**TOWN OF PALM BEACH**  
Planning, Zoning & Building Department  
360 South County Road  
Palm Beach, FL 33480  
(561) 838-5431 • [www.townofpalmbeach.com](http://www.townofpalmbeach.com)

**PZ&B Staff Combination Memorandum: Landmarks Preservation Commission and Town Council**

**SUBJECT:** COA-24-014 (ZON-24-050) 218 PHIPPS PLAZA (COMBO)

**MEETING:** MAY 22, 2024, LPC  
JUNE 12, 2024, TC

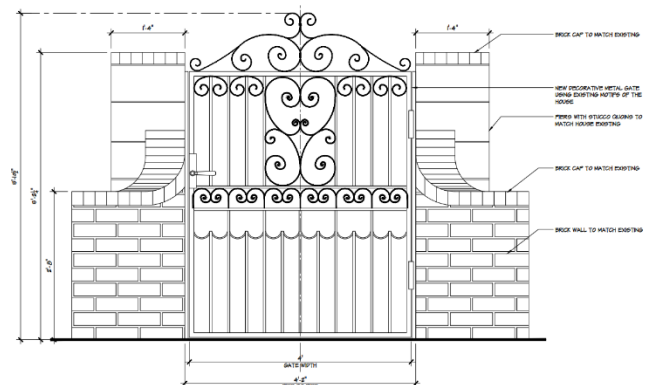
The pedestrian gate was modified in the following ways:

- The width was reduced from 5'-4 1/2" to 4'-0".
- The design was revised from a double gate to a single gate with modified metal work.
- The setback was increased from 9'-10 1/2" to 12'-0" from Phipps Plaza.

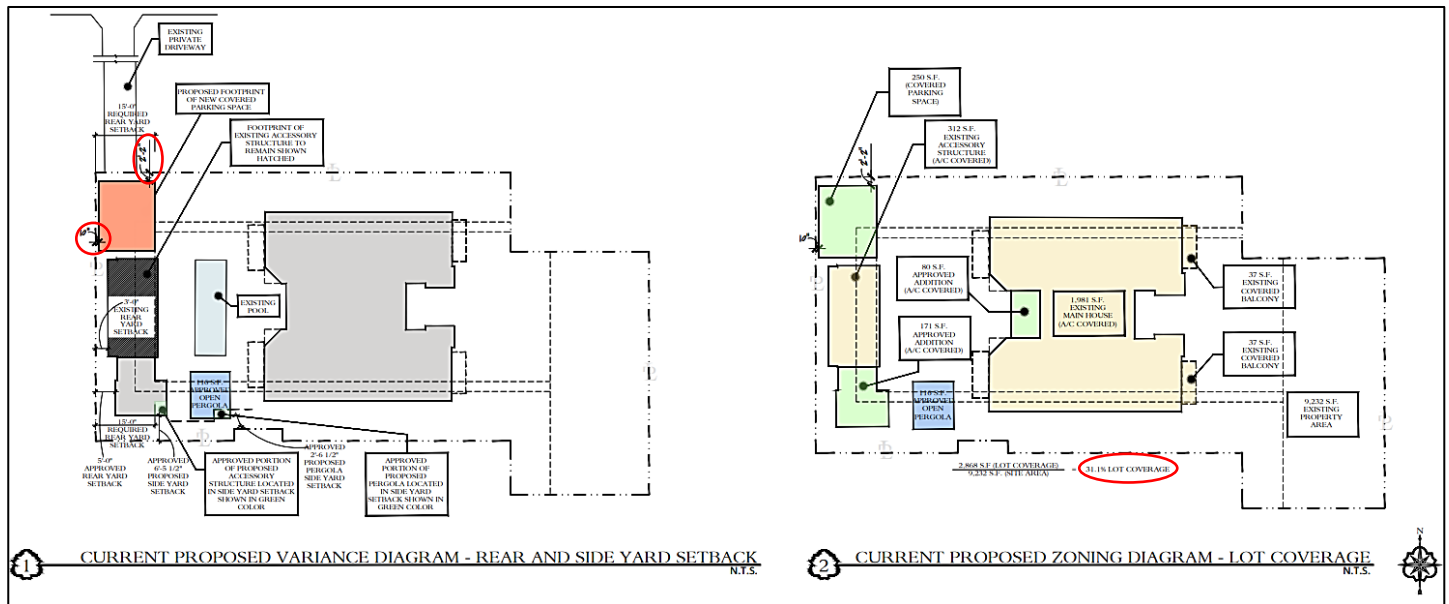
More specifically, the application as proposed requires three (3) variances for construction. As the diagram below illustrates, **Variances 1, 2, and 3** seek to increase the lot coverage to 31.1% in lieu of the maximum 30% per Section 134-893(b)(11), decrease the rear yard (west) setback to 11" in lieu of the required 10'-0" per Section 134-893(b)(9), and decrease the side yard (north) setback to 2'-2" in lieu of the required 12'-6" per Section 134-948(7).

Code Section	Required	Proposed	Variance
<b>Variance 1:</b> Sec. 134-893(b)(11)	30% Lot Coverage Maximum	31.1% Proposed Lot Coverage	<b>1.1%</b>
<b>Variance 2:</b> Sec. 134-893(b)(9)	10'-0" Minimum Rear Setback	10" Proposed Rear Setback	<b>9'-2"</b>
<b>Variance 3:</b> Sec. 134-893(b)(7)	12'-6" Minimum Side Yard Setback	2'-2" Propose Side Yard Setback	<b>10'-4"</b>
